RE: New Hampshire Site Evaluation Committee Docket No. 2015-06 Joint Application of Northern Pass Transmission, LLC and Public Service Company of New Hampshire d/b/a Eversource Energy for a Certificate of Site and Facility for Construction of a New High Voltage Transmission Line in New Hampshire

Docket No. 2015-06

PEMIGEWASSET RIVER LOCAL ADVISORY COMMITTEE'S MOTION TO COMPEL APPLICANTS TO RESPOND FURTHER TO DATA REQUESTS AND DISCOVERY QUESTIONS - SET 1

Bridgewater to Ashland ROW Crossing: Pemigewasset River

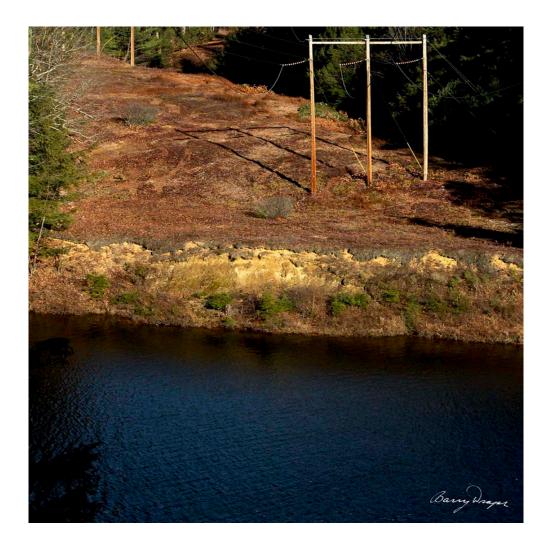
There is significant shoreland erosion damage at all five existing Pemigewasset River above ground crossovers (20 shorelines) starting at Ashland to Bridgewater and extending through Hill. The Project will add to the damage. Please specify, in detail, how you intend to bring all crossings up to SWQPA standards from reference line to 150'.

The Applicant states they do annual inspections of all transmission lines and associated ROW's today (PRLAC 1-26), yet they are unaware of bank destabilization/erosion issues at existing Pemi ROW crossovers. PRLAC pictures (1-7P) attached show past/present erosion along the reference line at a sample of these sites.

In the spirit of SWQPA RSA-483B, PRLAC works with riparian landowners to provide buffers to manage and prevent destabilization. For example: Structures should be a minimum of 150' from the ROW reference line. All vegetation in the 150' buffer protected area should not be mowed but trimmed to maintain a height of ~ 60 ". There is no justification for mowing to ground level at these locations.

We repeat the original question PRLAC 1-7 and provide visual evidence of PRLAC's concerns.

Given the destabilized condition of ROW crossovers (i.e. Ashland to Hill) on the Pemigewasset River today, PRLAC has concerns about the adequacy of these inspections. We again refer the Applicant to photographs included in this document (PRLAC 1-7).
